Accelerator Around IP

2015-1209 ILC Tokusui WS

Design Changes Since TDR : Change Requests Related to IP

CR2: Common L^*

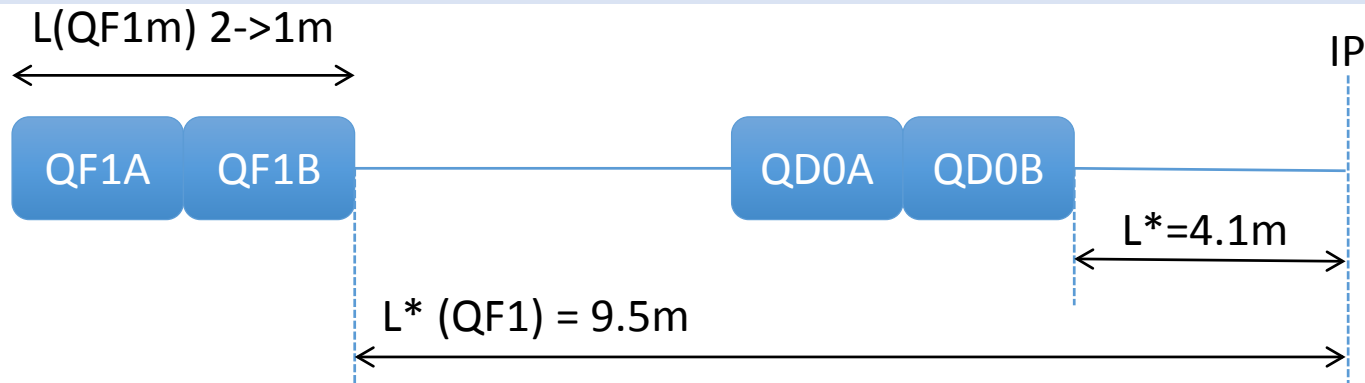
- Change request from accelerator side to make L^* common to SiD and ILD for easier commissioning and tuning
- SiD designed with $L^*=3.5$ m can relatively easily accept L^* between 2.6 and 4.5 meters.
- ILD designed with $L^*=4.5$ m can accept the minimum L^* of 4.1 m by removing the ion pump in front of QD0.
 - Increased pressure seems to be acceptable
 - Backup solution using a distributed NEG system is under consideration. Seems ok.
 - Further modification (e.g., redesign FCAL) needed if $L^*<4.1$ m is required
- The difference between $L^*=4.0$ and 4.1m is negligible from the optics and tuning standpoint.
- Once L^* decided, there is still a choice for QF1 L^* (9.5m in TDR)
 - Shorter QF1 L^* leads redesign of QF1 support structure and Packman both on SiD and ILD.
 - But 9.5m and 9.1m do not cause significant difference in optics

CR6: Additional BPM

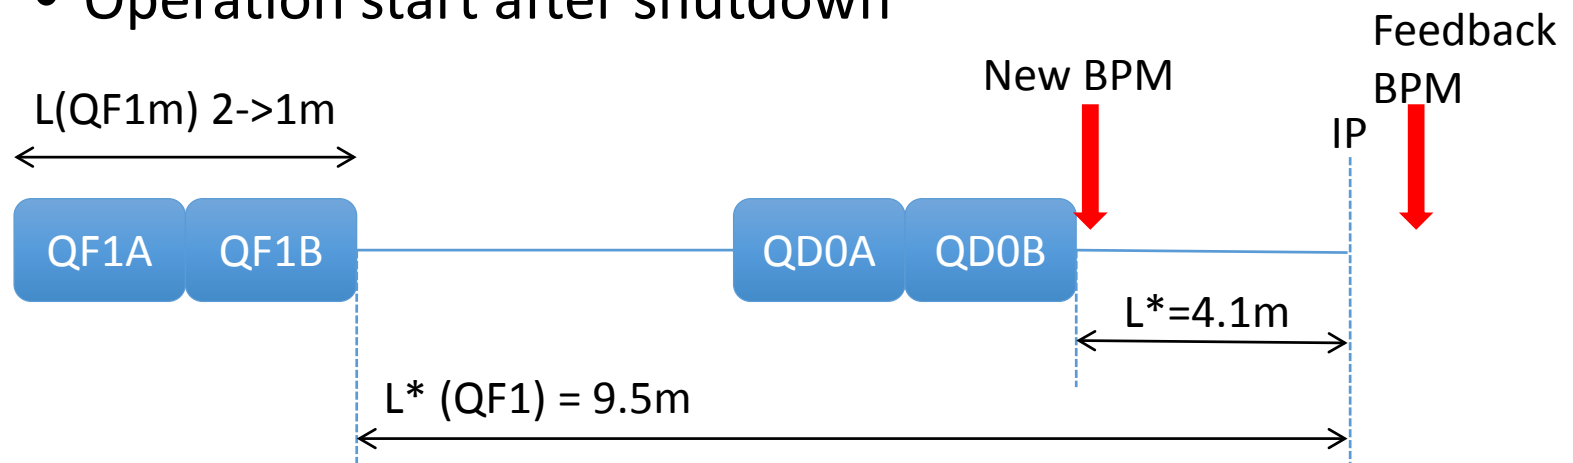
- Add a BPM just downstream of QD0
- Together with the stripline BPM for IP feedback, this will give the IP location to the accuracy better than $10\mu\text{m}$. (Same type BPM will work.)
- Will be useful for
 - Commissioning
 - Operation start after shutdown

CR4: Extension of Main Linac Tunnel

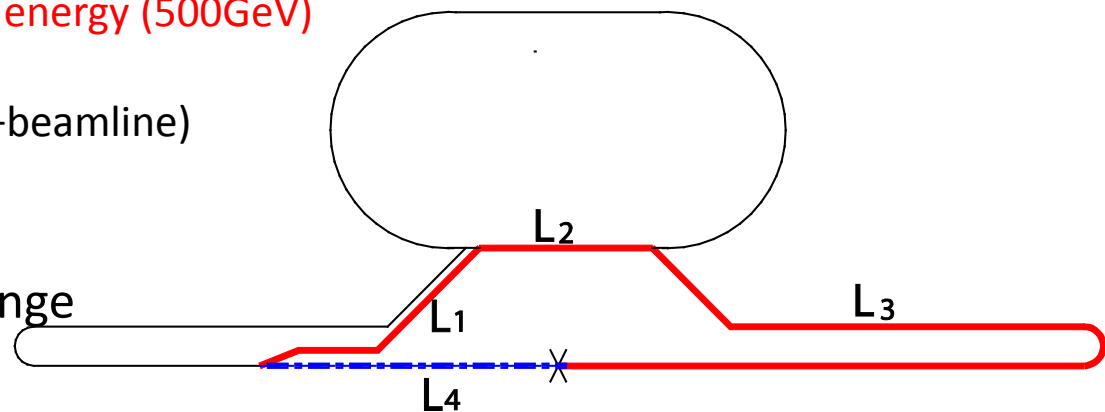
- Global timing issue
 - $(L_1 + L_2 + L_3) - L_4 = n \times C_{DR}$
 - Linac (positron) tunnel length discrete by $C_{DR}/2$
 - TDR values $(L_1 + L_2 + L_3) - L_4 = 9 \times C_{DR} + 294\text{m}$
 - Near-TDR solution
 - Decrease BDS by $294\text{m}/2$
 - Increase C_{DR} by $\sim 40\text{m}$
- Perhaps more reasonable solution is to increase the linac tunnel length by $2 \times 1.5\text{km}$
 - Empty tunnel (with beamline) in the first construction
 - Future margin $\sim 14\%$ for
 - Acceleration gradient ($31.5\text{MV}/\text{m}$)
 - Maximum reachable energy (500GeV)
 - Cost impact
 - ~ 100 MILCU (tunnel+beamline)
- Additional equipment
 - Positron chicane in L1 to adjust 10's of cm range

BSY Changes & Structural Changes to Lattice Files

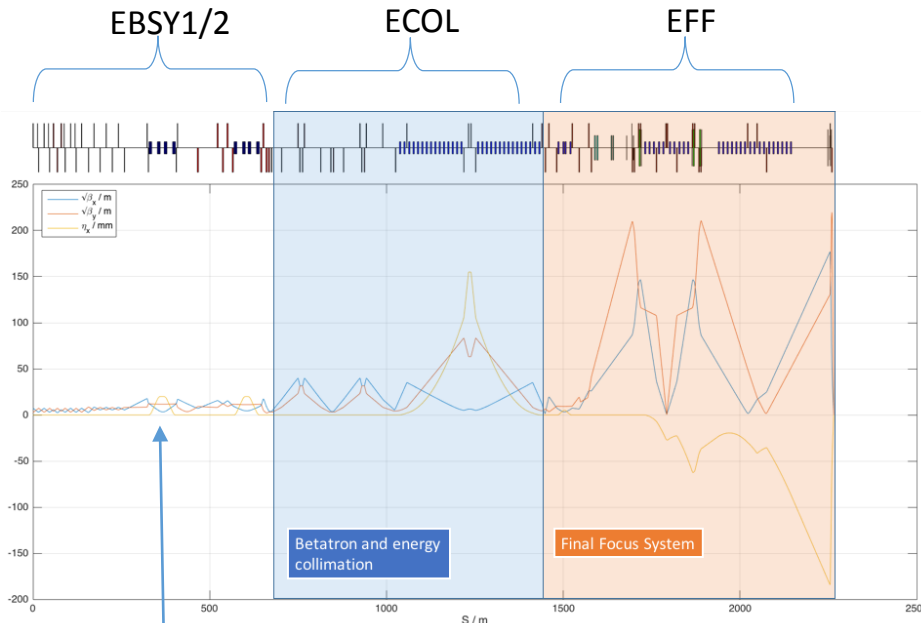
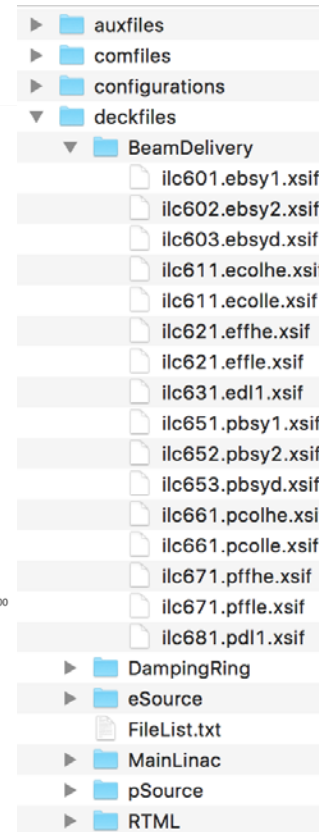
LW chicane shortened

- BSY length decreased by 23.87 m
- photon path length (undulator exit to target) decreased by 12.23 m

ILC2015b: pBSY

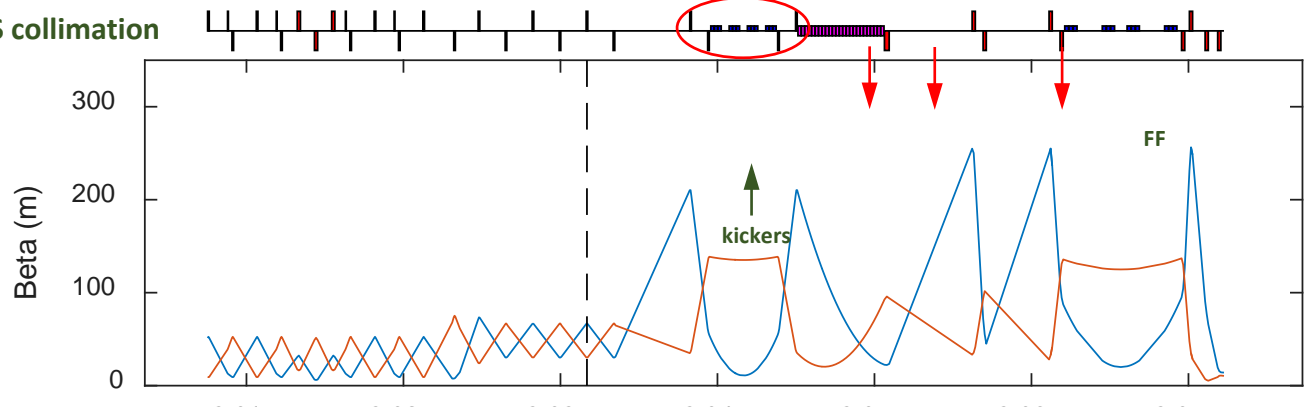
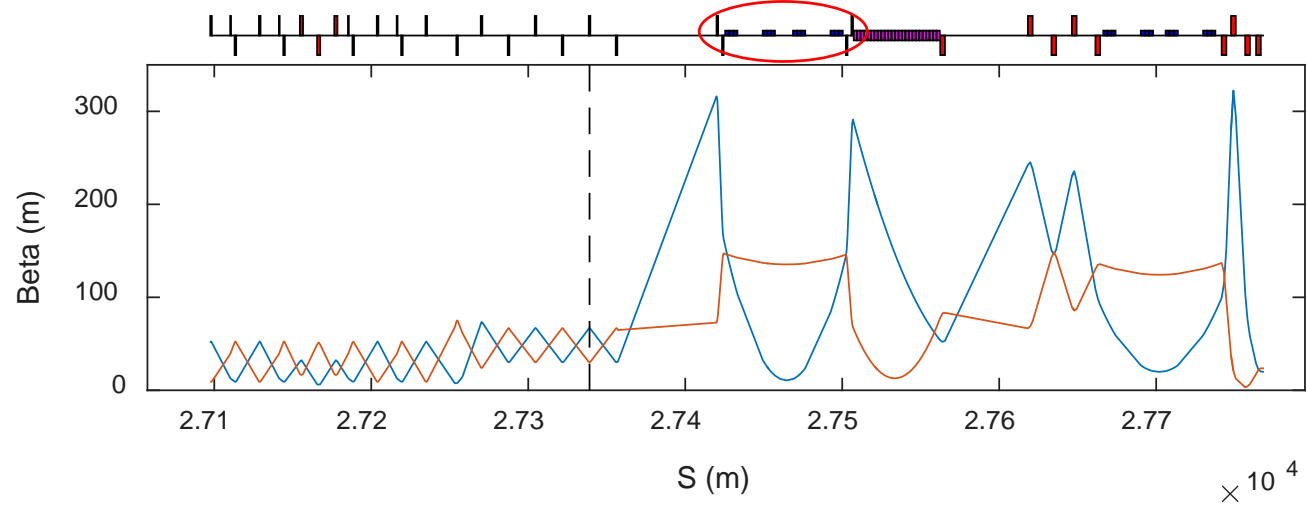
- R2015a EFFS1
- -> R2015b:
 - ECOLLE / ECOLHE
 - EFFLE / EFFHE
 - LE: $E_{CM} \leq 500$ GeV
 - HE: $E_{CM} > 500$ GeV
- (E = electron, P = positron)
- Identical
